DS3112

TEMPE T3 E3 Multiplexer

REVISION B2 ERRATA

Figure 1. Timing Diagram

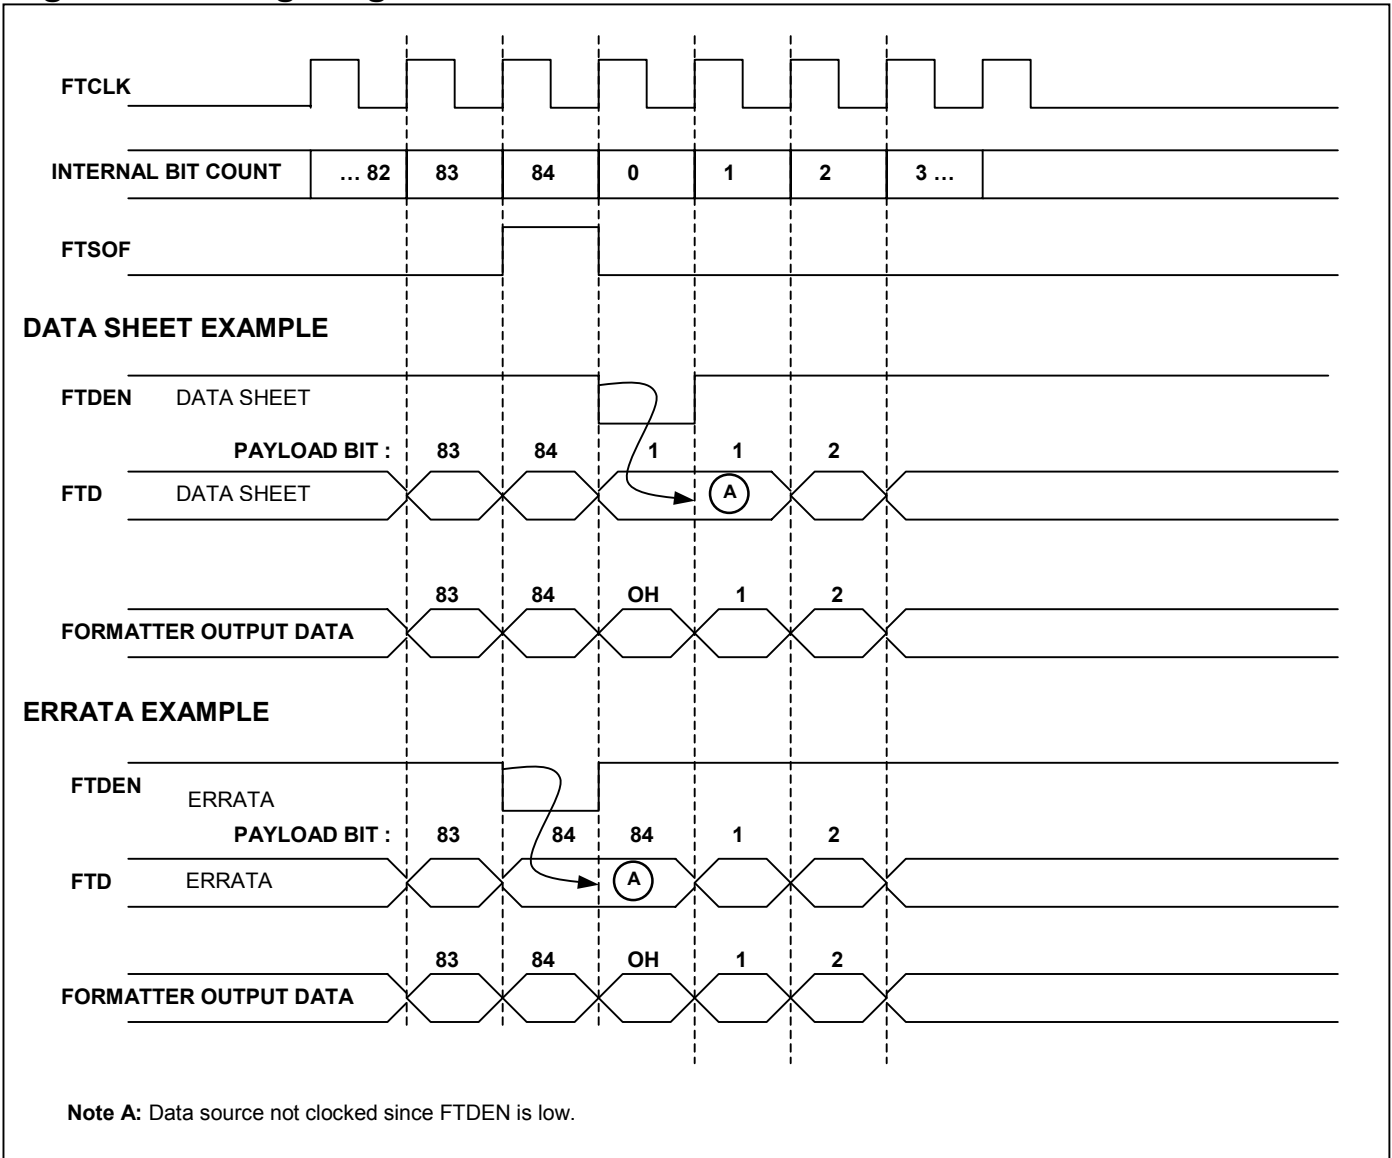
The FTDEN output pin (T3/E3—transmit formatter serial-data enable) pulses one clock cycle earlier than specified in Figure 2.4A of the DS3112 data sheet. This occurs in T3 mode only. FTDEN is early for both data-enable and gapped-clock modes of operation. This only affects unchannelized T3 operation; channelized T3 and E3 are not affected.

This erratum has no affect on the output data stream. Figure 1 shows that whether FTDEN pulses per the data sheet or one cycle early, the formatter output data is the same. The overhead bit is properly inserted between payload bit 84 and payload bit 1. The example in Figure 1 depicts the DS3112 where FTDEN is configured as a data enable. The gapped clock case is identical.

Use an external flip-flop to delay the FTDEN signal one clock cycle.
